8T8R board layout Review

AFE77XX

Vias STX/SRX Lanes

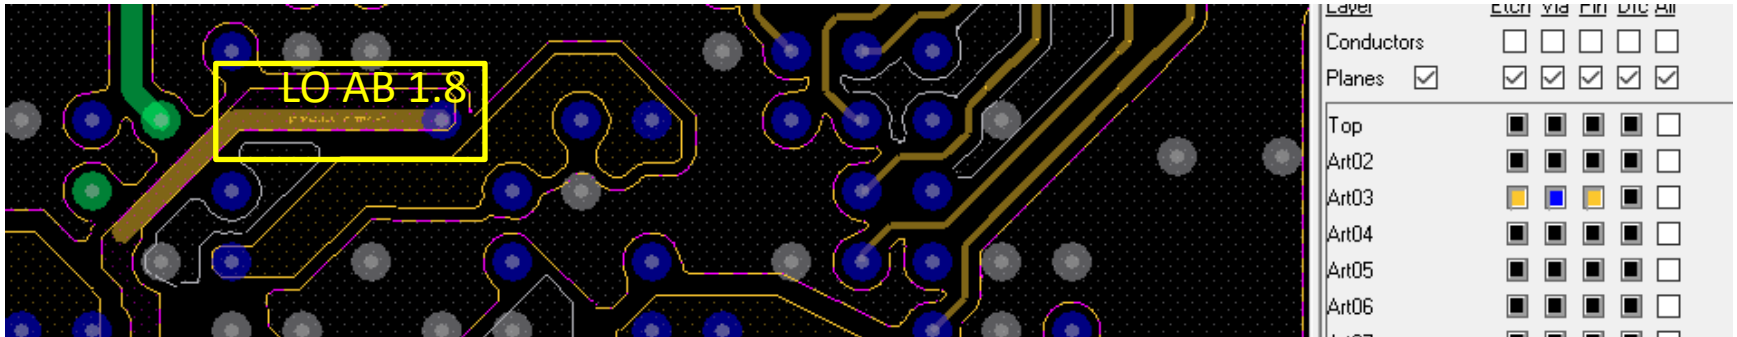
STX/SRX lanes are on Art03 and AFE is in bottom. Is there a backdrill on these Vias. Else it will create a stub and can cause reflection at 24G operation

LO/DC PLL Supplies

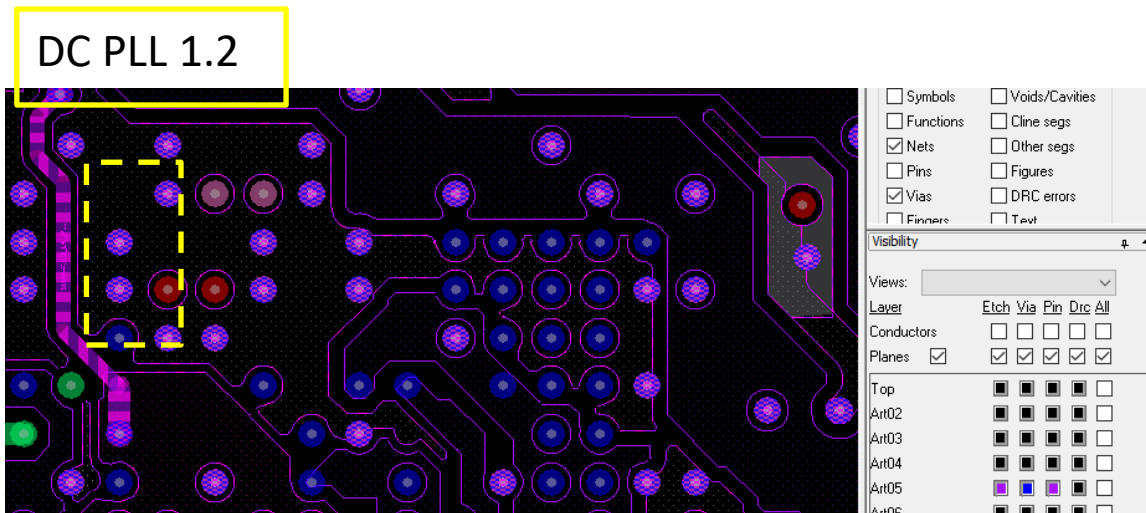
1.8V LO AB Supply shouldn't be routed as trace. A plane is preferred as it is sensitive to coupling. May cause spurs/Phase noise degradation. We cannot predict the impact

DC PLL 1.2 LO is a switching supply. Can be given larger plane in the highlighted area

TX LO mixer supply decoupling

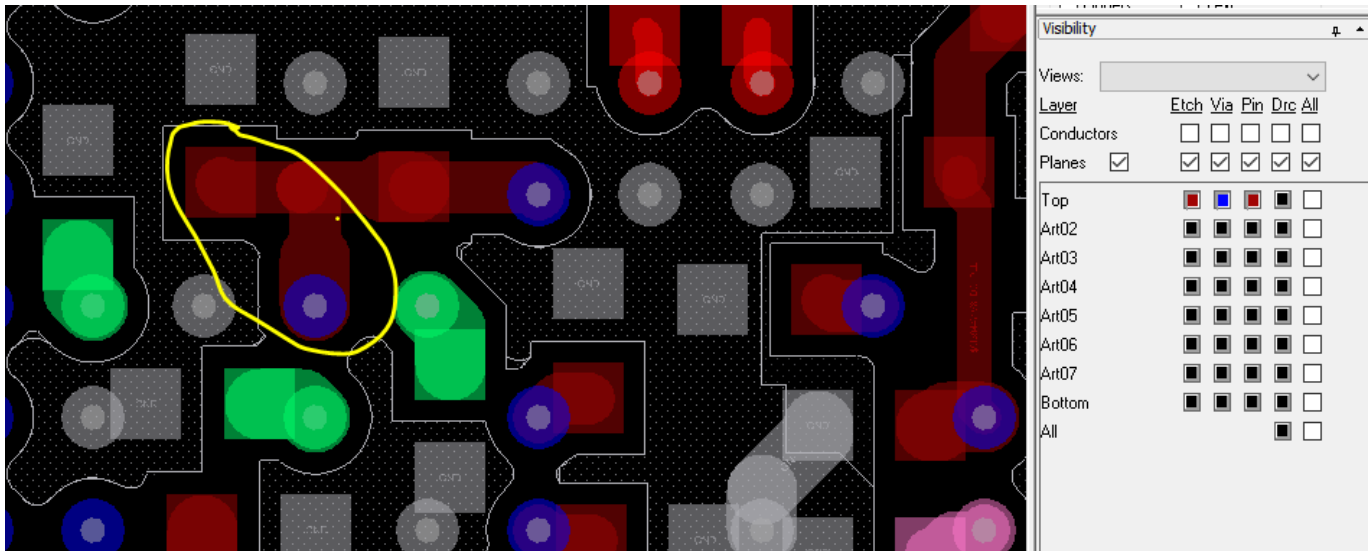
Dcap on pin P15/R15(TX LO supply) can be moved closer to the Via
Other important pins are F13/G13(for TX) and T9/E9 (for RX). They look okay.
